Latest Vehicle Concern Fixes

| Air Conditioning Hose Clash | 20MY Defender |

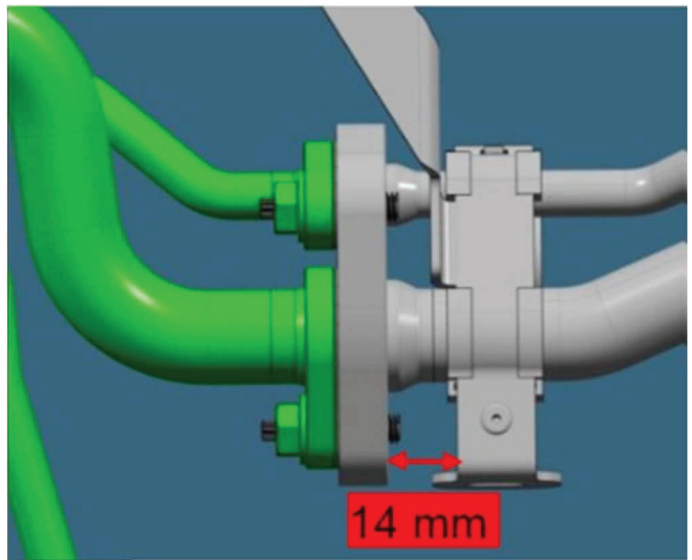
| Air Conditioning Hose Clash | 20MY Defender |
|---|--|
| <p><u>Customer Voice:</u></p> <ul style="list-style-type: none">• A customer may report an abnormal noise (like a humming, buzzing, or grinding) when accelerating or decelerating. <p><u>Technical Description:</u></p> <ul style="list-style-type: none">• The air conditioner refrigerant line may clash with the FEAD belt tensioner pulley intermittently as the tensioner moves based on belt load, due to misalignment of the line in the retaining bracket.• This applies to INGENIUM I6 engine variants only. <p><u>Status:</u></p> <ul style="list-style-type: none">• A SSM is being drafted for publication to address this concern.• The a/c refrigerant line position in the clamping bracket will required repositioning to correct the clash condition.• Take care when adjusting AC hoses not to induce stress as this may generate cracks or leaks in the system. |  |

Incorrect

14 mm

correct
